Subject: Submittal Supporting Accelerated ABWR Review Schedule - **DFSER Open
Item 3.8.3-1 and COL Action Item 9.4.8-1**

Enclosed are SSAR markups addressing DFSER Open Item 3.8.3-1 and COL Action Item 9.4.8-1.

Figure 9.4-7 SERVICE BUILDING VENTILATION SYSTEM

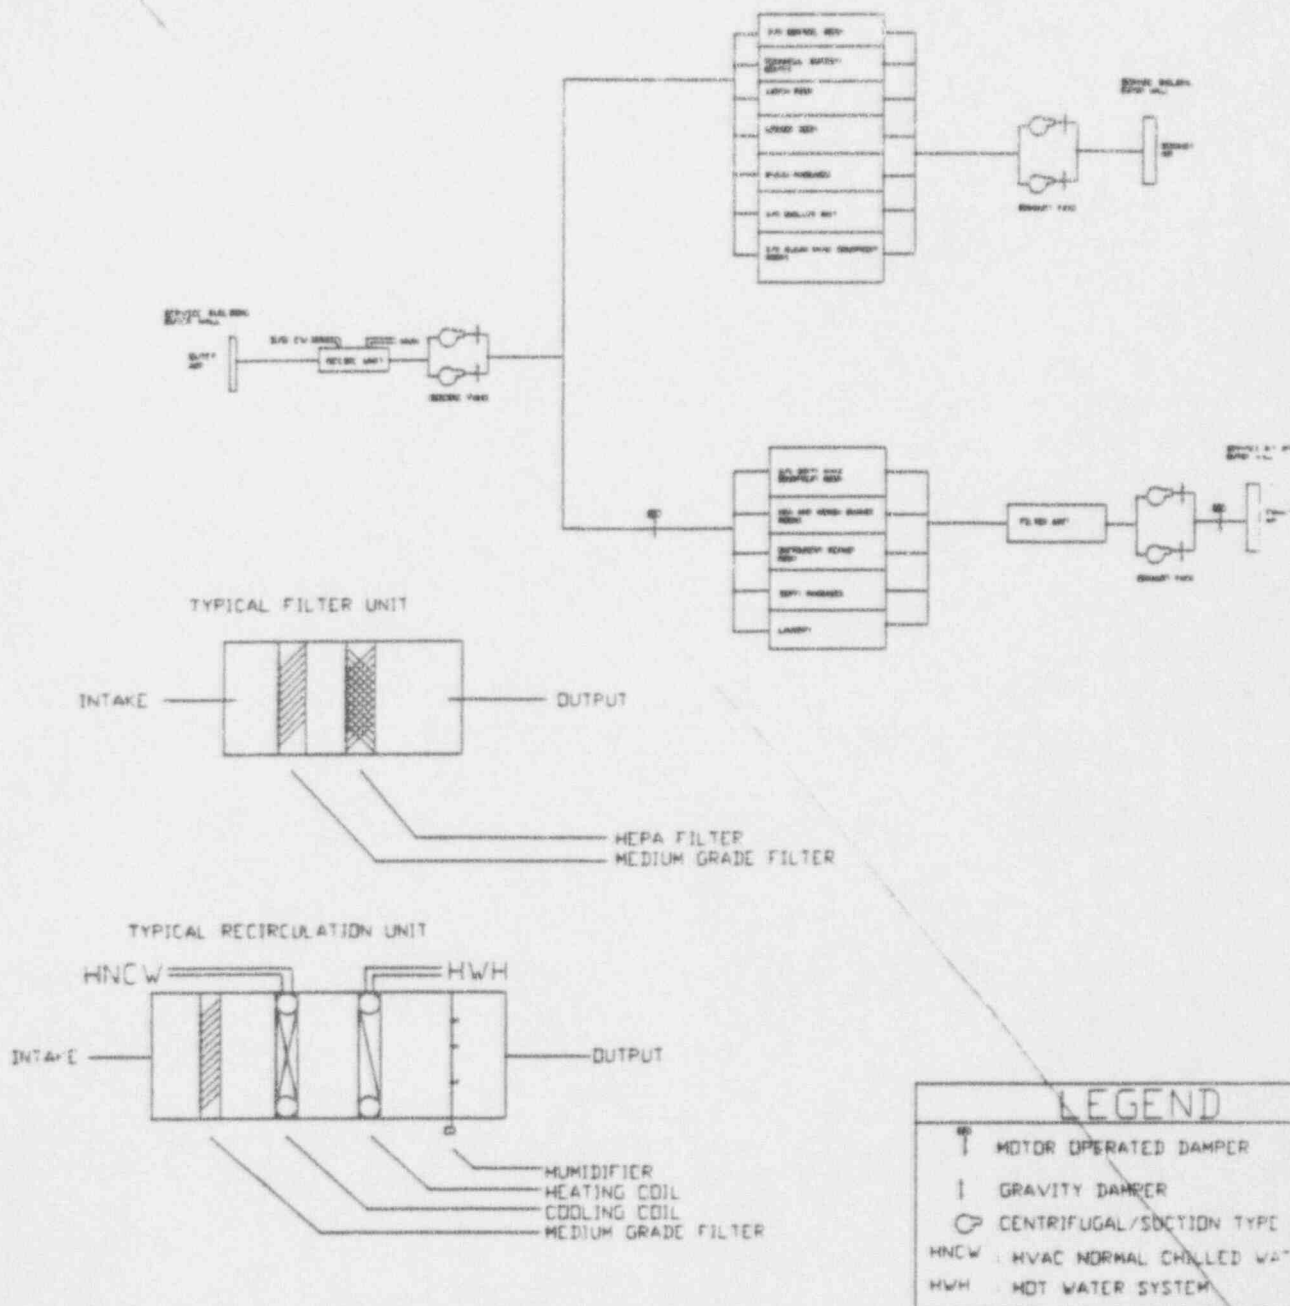
- (1) The schematic design of the service building ventilation system is shown on Figure 9.4-7.
- (2) The service building ventilation system supplies filtered, heated or cooled air to the general areas through a central fan system consisting of an outside air intake, filters, a heating coil, a cooling coil, two 50% capacity supply air fans, and supply air ductwork.

insert a

- (5) The clean areas served by the service building HVAC system has an emergency filter train. It is manually operated. In an emergency it supplies filtered air for the TSC and other normally clean areas.

insert b

- (6) The clean areas of the service building is provided with an emergency filter train consisting of a heater/demister, prefilter, HEPA filter, 2" charcoal filter bed, a second HEPA filter, and a fan.

insert c

- (8) The COL applicant will provide a detailed P&ID and an equipment list, for the service building HVAC system, including the TSC, for NRC review. (See Subsection 9.4.10.1 for COL License Information)
